PROJECT: MODULAR FURNITURE – CORPORATE SERVICES SECTOR (6/F), ESPRESSO CAFÉ-LIBRARY, MAIN BUILDING STAGING AREA & TREASURY DIVISION, CASH DEPARTMENT, SECURITIES SETTLEMENT AND CUSTODY DEPARTMENT, LIQUIDITY MANAGEMENT BANK DEPOSITS DEPARTMENT

QUERIES/CLARIFICATIONS RAISED DURING THE PRE-BID CONFERENCE:

WRITTEN QUERIES:

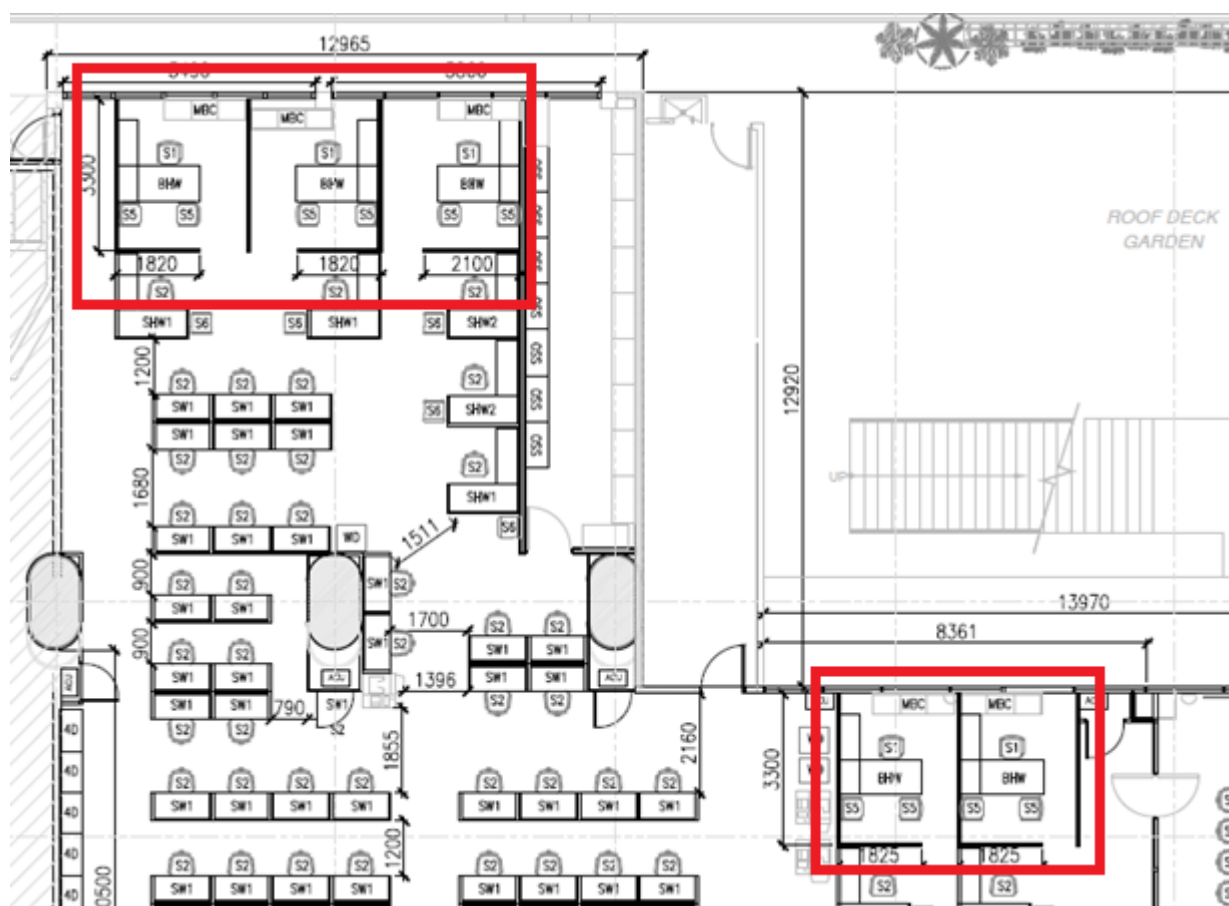
Query/Clarifications	TWG/BAC Reply
1	Under Lot 3 of item 4. Modular Partition (Executive Offices), what is the width dimension?	The width varies from 1.82 m to 3.3 meters, you may refer to the attached Furniture Layout for the dimension or see attached Annex A-1.
2	Under BOQ Lot 4 of Treasury Division letter A. Executive Workstation, where did the 1.0 Worktop 2000mm L x 750mm D x 740 mm H come from?	It is the size of the worktop.
